# UNITED STATES PATENT AND TRADEMARK OFFICE

APPLICATION NO.	FILING DATE	FIRST NAMED INVENTOR	ATTORNEY DOCKET NO.	CONFIRMATION NO.
10/594,849	04/02/2007	Hans-Georg Brauer	628/08	3648
27538 7590 06/21/2011 GIBSON & DERNIER LLP 900 ROUTE 9 NORTH SUITE 504 WOODBIDGE, NJ 07095			EXAMINER REDMAN, JERRY E	
			ART UNIT 3634	PAPER NUMBER
			MAIL DATE 06/21/2011	DELIVERY MODE PAPER

### Office Action Summary

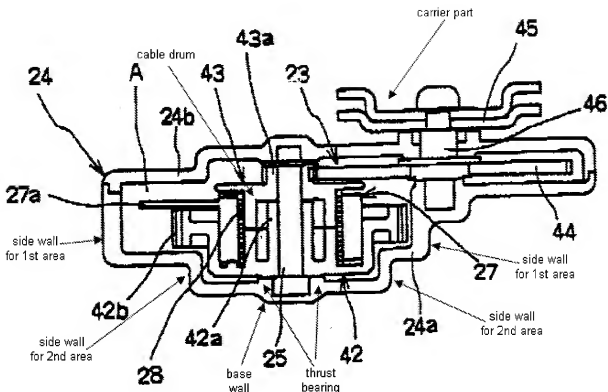
Claims 1-3, 5, 8-12, and 15 are rejected under 35 U.S.C. 102(b) as being anticipated by Shimizu (6,758,012 B2). As shown in detail below, Shimizu (6,758,012 B2) discloses a vehicle having a vehicle door (column 3, line 14, i.e.,) having a module (all inner mechanisms of a vehicle door), a carrier part (24) integrally formed with a drum housing (24a) having side walls, a back wall having a thrust bearing integrally formed thereon, and the housing (24a) having a first diameter area (see Figure below) and a second diameter area larger than the first diameter area (see Figure below).
